FIGURE 3.1-1 ROD GROUP INSERTION LIMITS VERSUS
THERMAL POWER 4 LOOP OPERATION

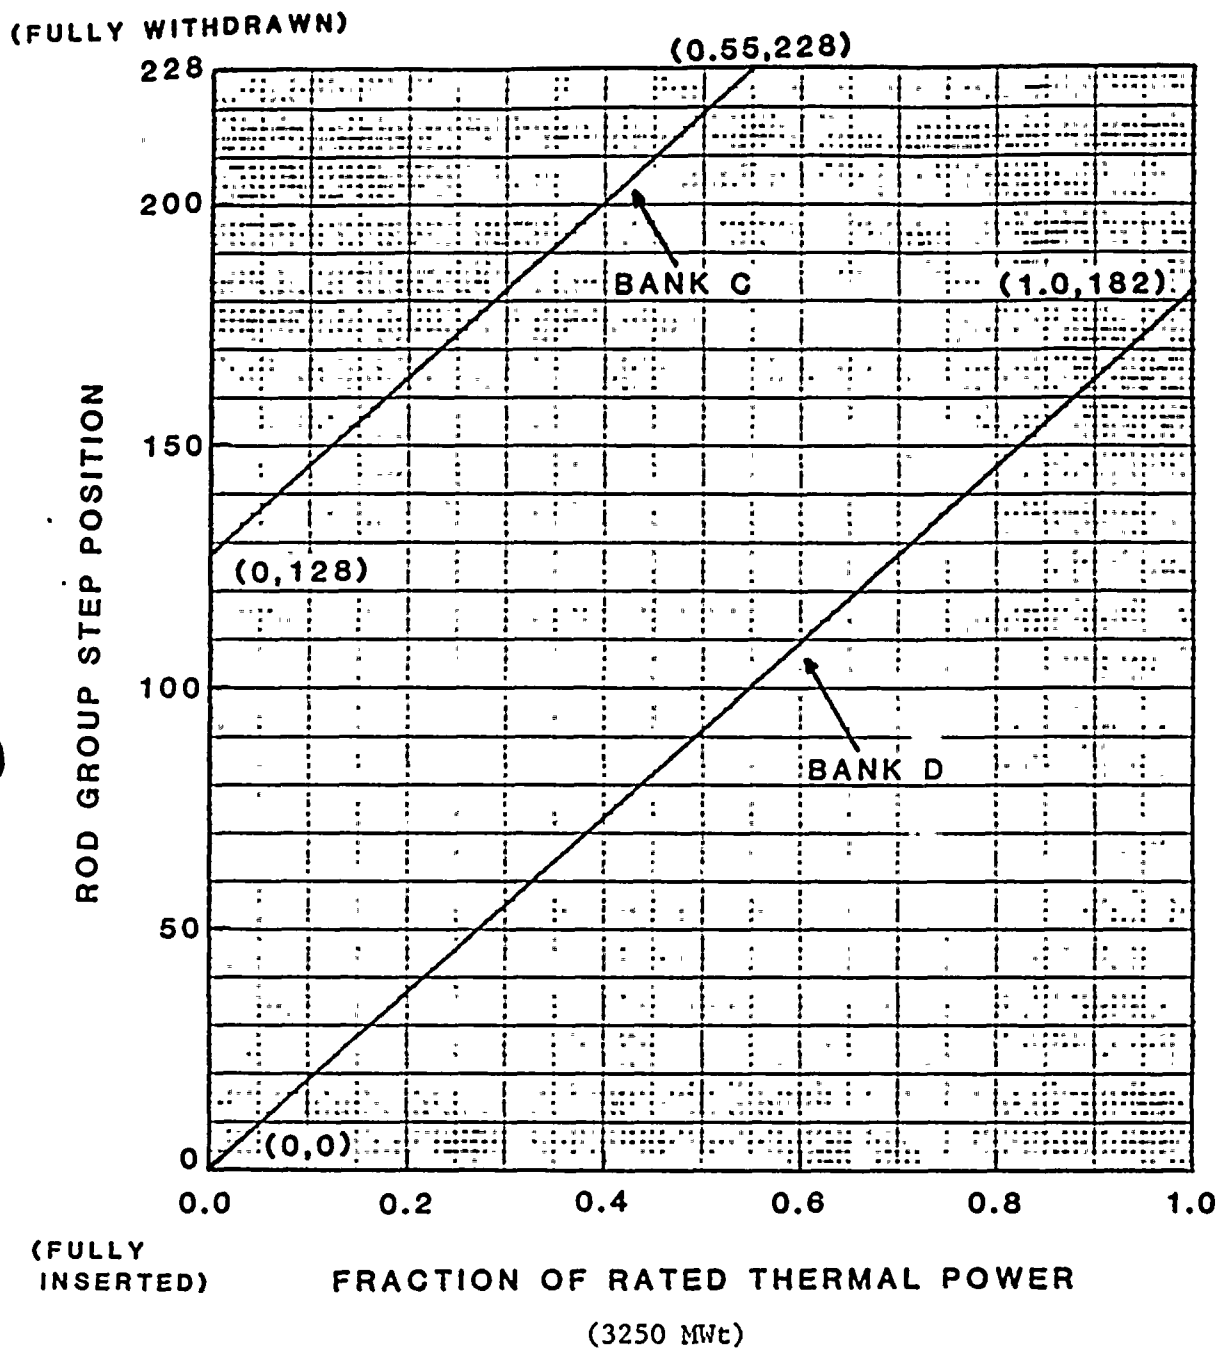
3/4 1-24; 3/4 1-25; 3/4 1-26	Figure 3.1-1 Figure 3.1-2	1	*	056	Rod Group Insertion Limits figure for 4 Loop Operation is redrawn with labeled endpoints.	Editorial change. See memo dated February 26, 1986, from F. J. Silva to J. C. Miller of Westinghouse Electric Corporation found in Attachment 7.
		2	*	057	Rod Group Insertion Limit figure for 3 Loop Operation is removed.	Three loop operation in Modes 1 and 2 will be prohibited.
		1		058	Rod Group Insertion Limit figure for 4 Loop Operation is renamed Figure 3.1-1.	Editorial change.
		1		059	Pages 3/4 1-25 and 3/4 1-26 are removed.	Editorial change; blank pages are unnecessary at the end of a section.

FIGURE 3.2-2 EXXON FUEL
K(Z) NORMALIZED VS. CORE HEIGHT

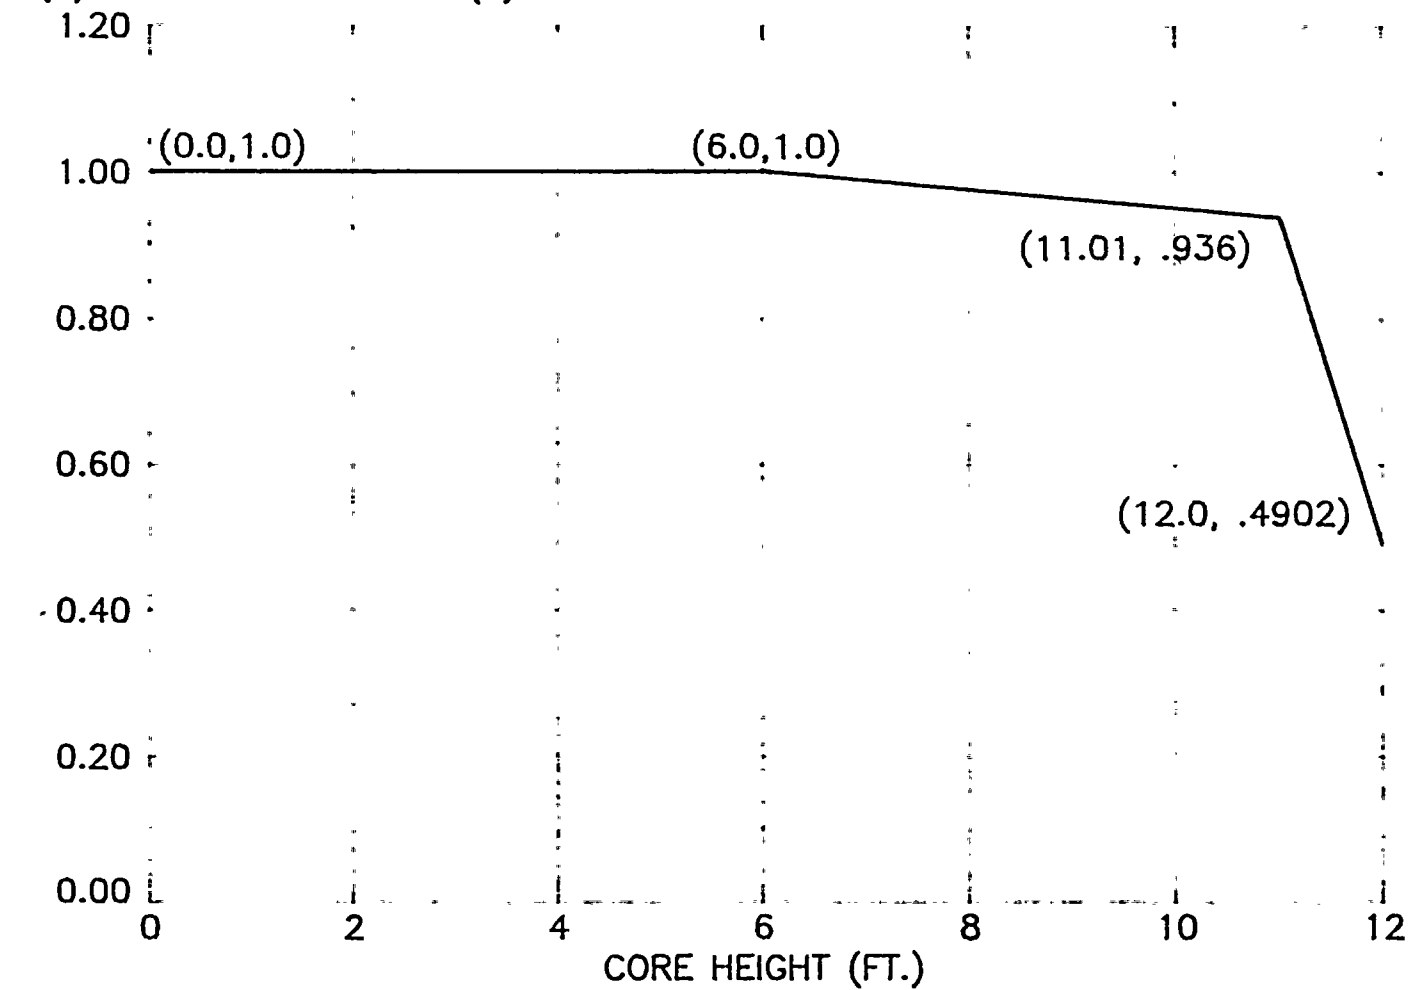
3/4 2-10	Figure 3.2-2	1	*	076	The figure is redrawn.	Editorial change for clarity.
		1		077	The page number is changed to 3/4 2-7.	Editorial change.
3/4 2-11	Figure 3.2-3	1		078	The figure is redrawn.	Editorial change for clarity.
		1		079	The page number is changed to 3/4 2-8.	Editorial change.
3/4 2-12	3.2.3	1		080	Mathematical symbols are written out in words.	Editorial change for clarity.
		1		081	"power" is changed to "POWER".	Editorial change. Thermal power is a defined term.

Figure B 3/4 2-1 TYPICAL INDICATED AXIAL FLUX DIFFERENCE
VERSUS THERMAL POWER AT BOL

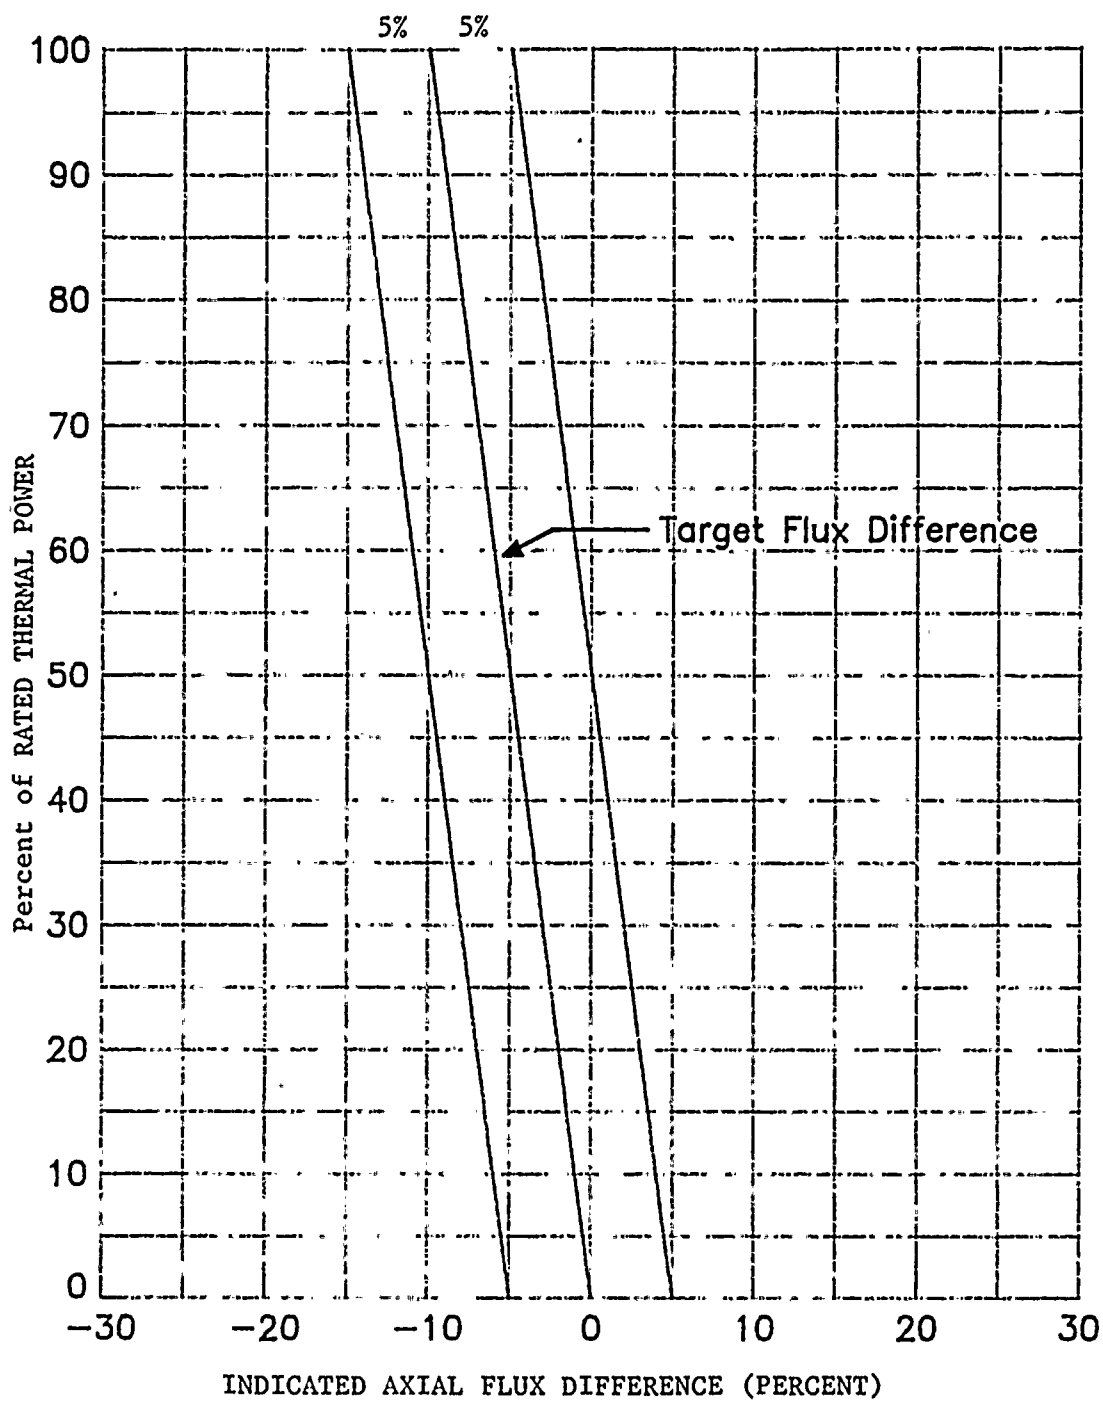
PAGE	SECTION	+ * #	DESCRIPTION	REMARKS
		B	212a Period replaced by comma.	Editorial change.
B 3/4 2-3	Figure B 3/4 2-1	B	212b Figure is redrawn.	Editorial change for clarity.
B 3/4 2-4	3/4.2.2 3/4.2.3	B	213 The words "nuclear enthalpy hot channel factor" changed to "nuclear enthalpy rise hot channel factor".	Editorial change; makes Technical Specifications for both units more similar.
		B * 214	References to F_O and F_{AH} expanded to include proposed APL Technical Specification.	Editorial change.
		B	215 (No change for this identifier).	
B 3/4 2-5	3/4.2.3	B	216 "physics tests" is changed to "PHYSICS TESTS".	Editorial change; physics tests is a defined term.
		B	217 Section on burnup dependent F_Q for Exxon fuel removed.	See remarks for Item 208.
B 3/4 2-6	3/4.2.5 (Bases)	B * 218	Discussion of flow rate surveillances are included.	Surveillance requirements revised to add CHANNEL CALIBRATION and flow measurement. Monthly flow surveillance is removed as redundant to shiftly surveillance. Resulting surveillance requirements are consistent with Unit 2 Technical Specifications. See Attachment 6, Item Number 10.

FIGURE 2.1-1 Reactor Core Safety Limits -
Four Loops in Operation

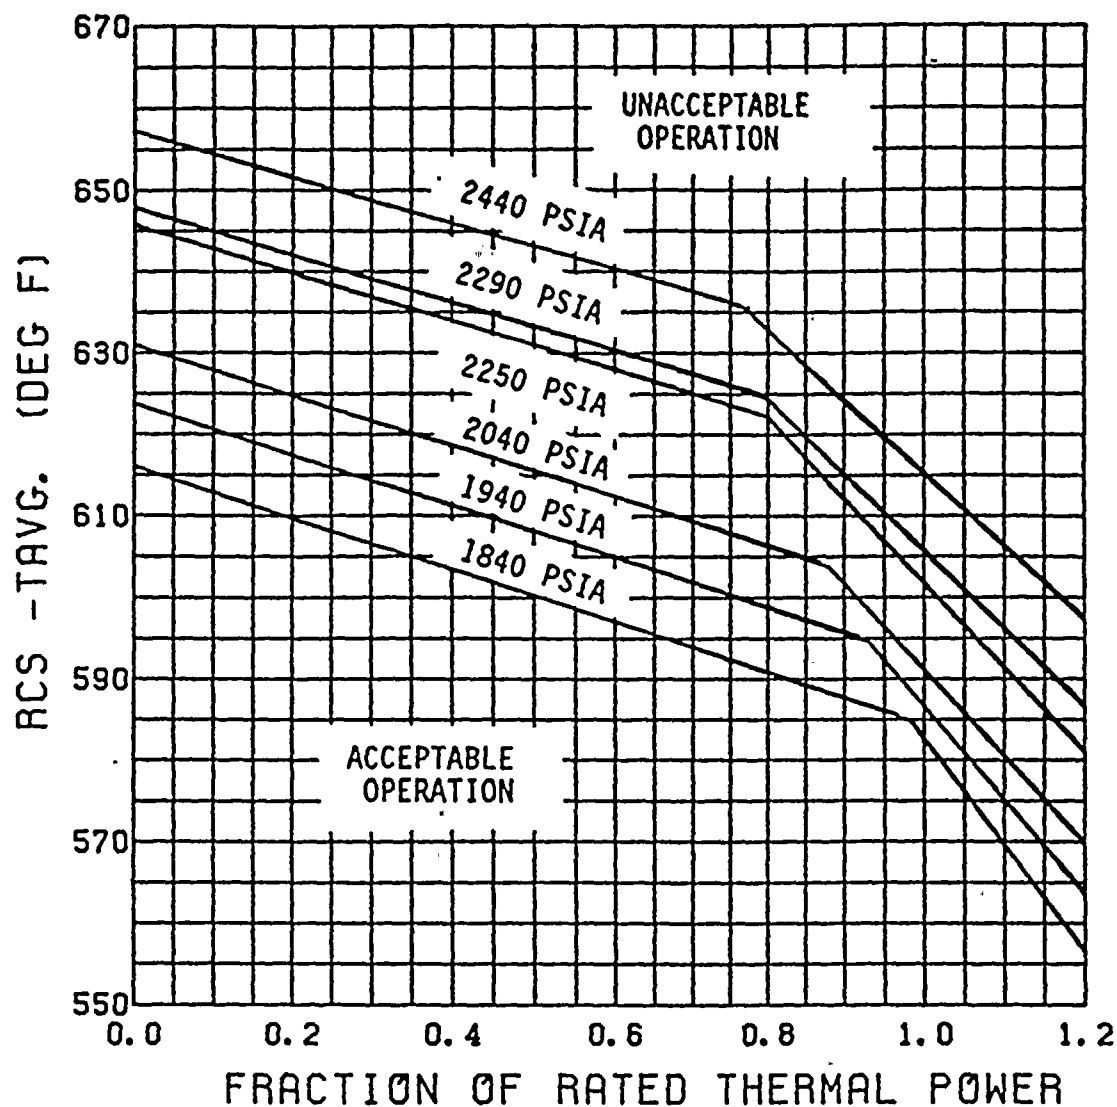
PAGE	SECTION	+	*	#	DESCRIPTION	REMARKS
2-2	Figure 2.1-1	1		231	Curve for 2250 psia is added.	Editorial change. See letter dated July 31, 1986, ENC-AEP/0511, H.G.Shaw to D.H.Malin found in Attachment 10.
3/4 1-3	4.1.1.2	1		232	Change "greater than" to "greater than or equal to".	Editorial change. Makes Unit 1 and Unit 2 more consistent.
		1		232a	Mathematical symbols are written out in words.	Editorial change for clarity.

FIGURE 3.1-2

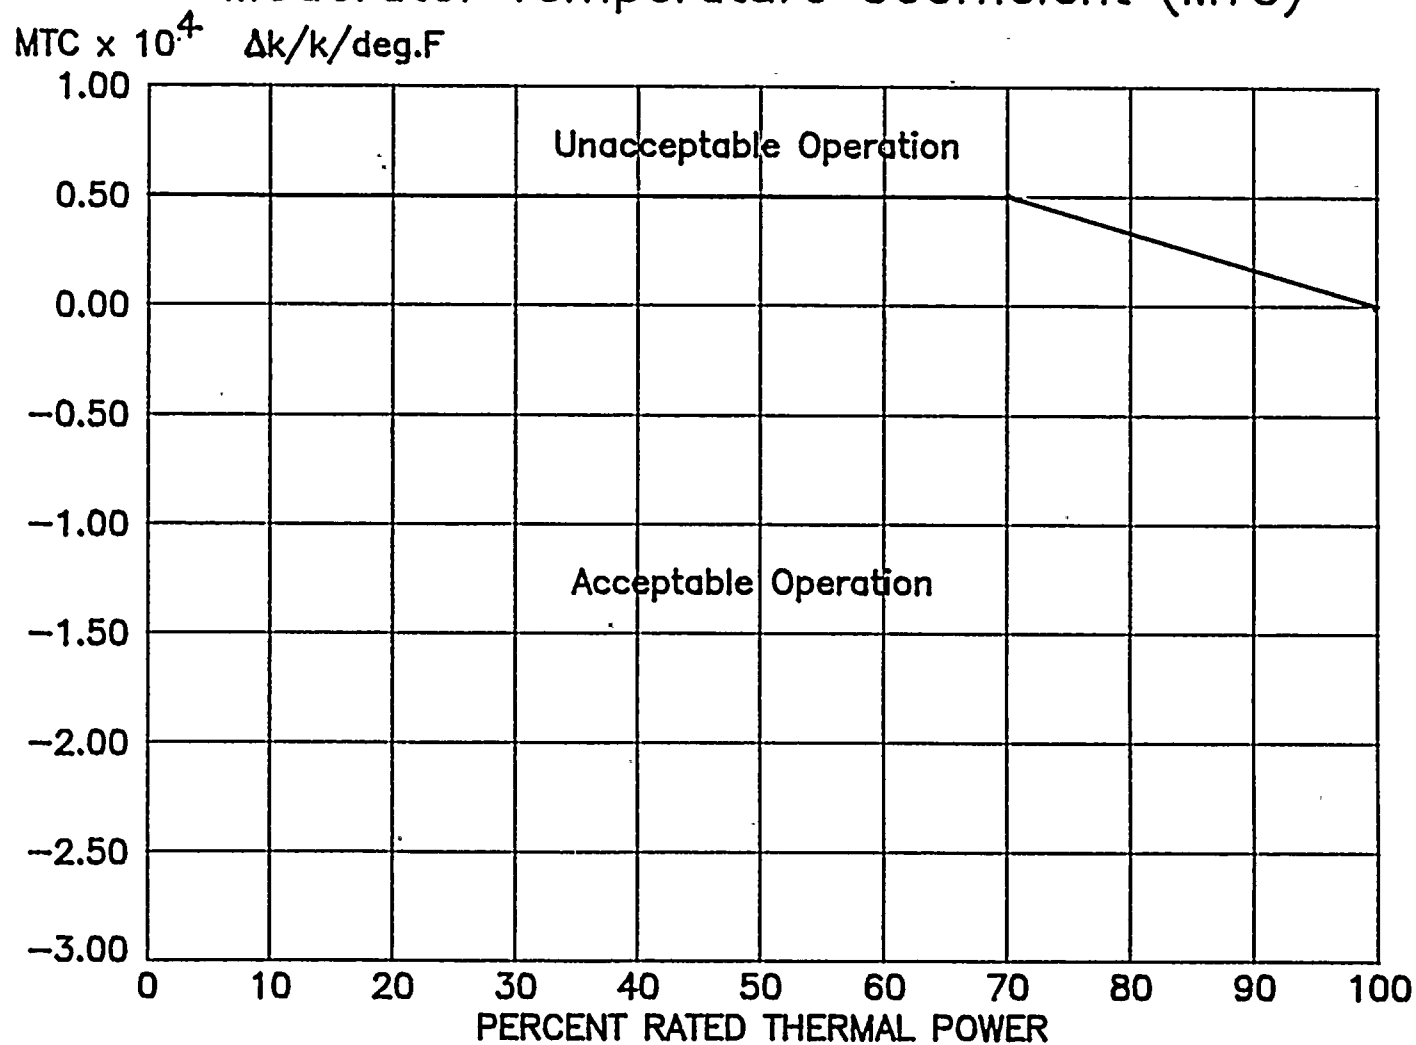
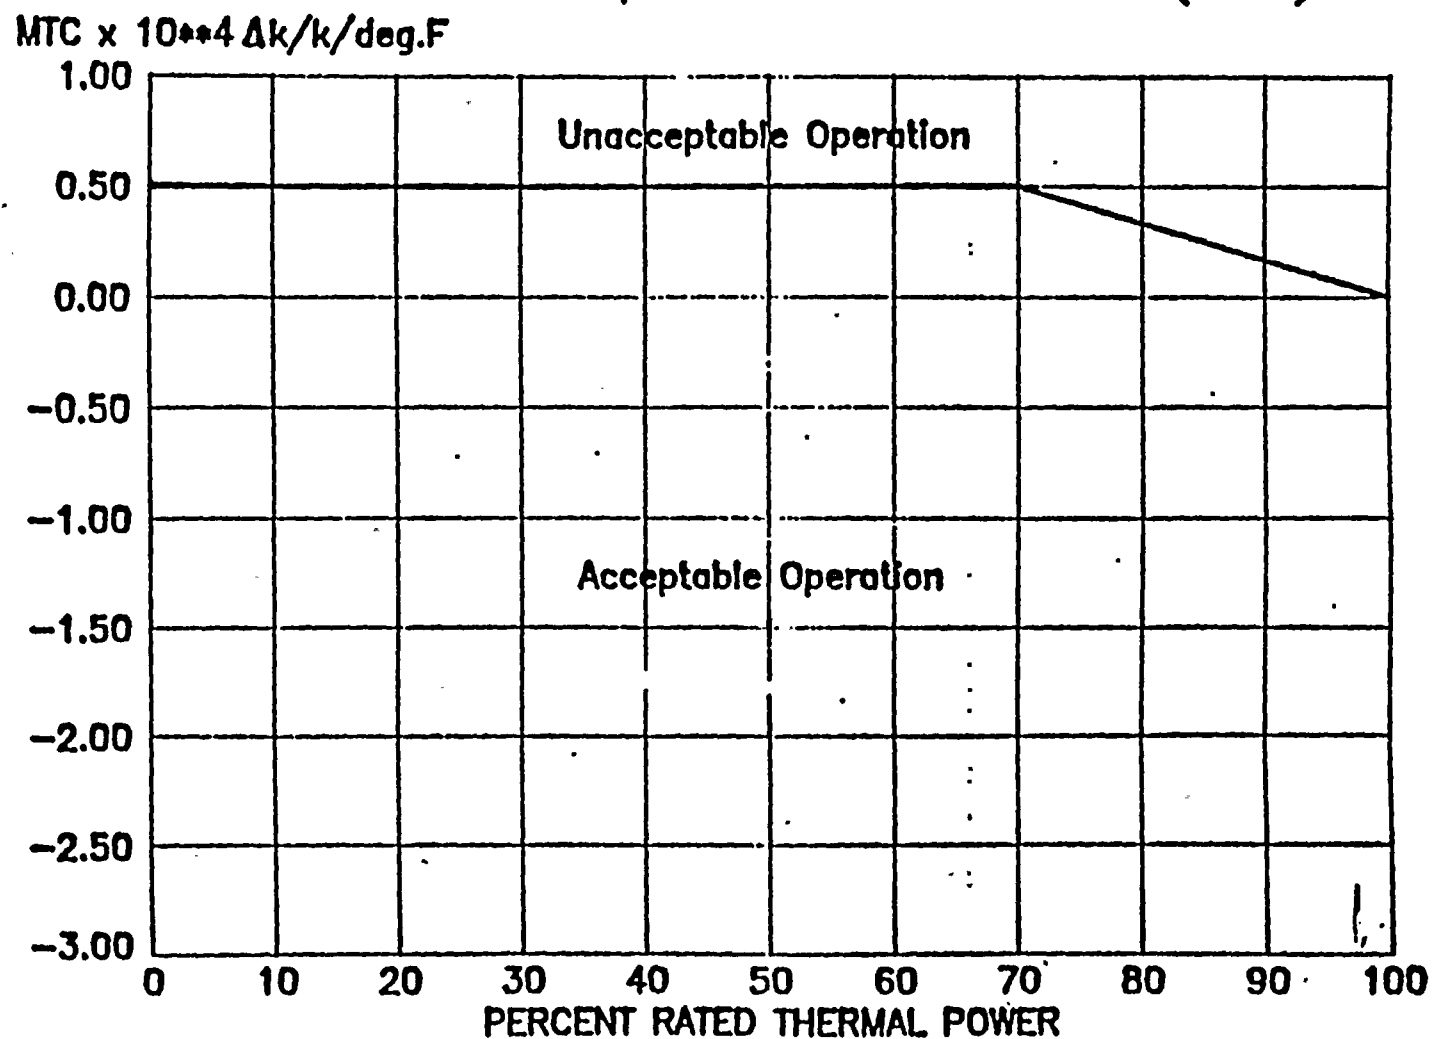
PAGE	SECTION	+	*	#	DESCRIPTION	REMARKS
		8		016	Flow rate requirement reduced to 2000 gpm.	An analysis was performed to reduce the required reactor coolant flow rate to 2000 gpm. See Attachment 5 for discussion of heat removal, mixing, and stratification considerations. See Attachment 14 for dilution transient considerations.
		4	*	017	Footnote added.	The Technical Specification boron concentration in the RWST is sufficient to provide adequate shutdown margin from expected operating conditions.
3/4 1-5; 3/4 1-5a	3.1.1.4 Figure 3.1-2	8		018	The upper limit on MTC for operation above 70% RTP is changed. The upper limit is now graphically displayed (see Item 020).	To improve operational flexibility. Justification provided in Attachment 6, Item Number 4.
		1		019	Mathematical symbols are written out in words.	Editorial change for clarity.
		1		020	The new MTC limits proposed in item 018 are now graphically displayed in Figure 3.1-2.	Editorial change.

4.1.1.4.b	1		236	Specified 300 ppm surveillance at "RATED THERMAL POWER equilibrium boron concentration".	Editorial change; change made to clarify the intent of the surveillance requirement.
		1		237	Mathematical symbols are written out in words.	Editorial change for clarity.
		1		238	The new MTC limits proposed in Item 235 are now graphically displayed in Figure 3.1-2 on new page 3/4 1-6a.	Editorial change.
